## Alliance for Automotive Innovation

### Comments To National Highway Traffic Safety Administration on The Safer Affordable Fuel-Efficient (SAFE) Vehicles Rule III for Model Years 2022 to 2031 Passenger Car and Light Trucks; Notice of Proposed Rulemaking

Docket ID No. NHTSA-2025-0491  
RIN 2127-AM76

February 4, 2026

Figure 6: Proposed Light Truck Targets, MYs 2027 and 2028.

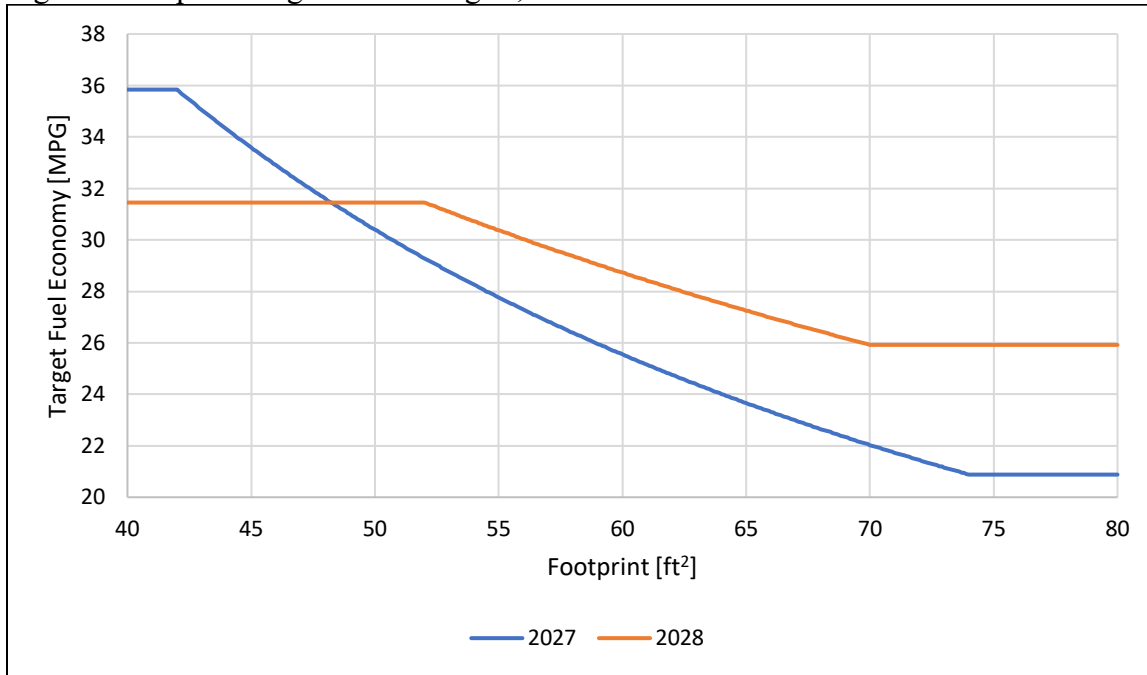
In Figure 6, we compare the light truck target functions for MYs 2027 and 2028. In the heart of the proposed targets, between 52 and 70 ft<sup>2</sup>, we note that the effective stringency increase for the remaining light trucks after reclassification is 7% to 15% in a single year.<sup>79</sup> For light trucks larger than the proposed 70 ft<sup>2</sup> cutpoint, stringency increases by up to 19.4% in a single year. (Please see our comments above regarding the proposed cutpoint.)
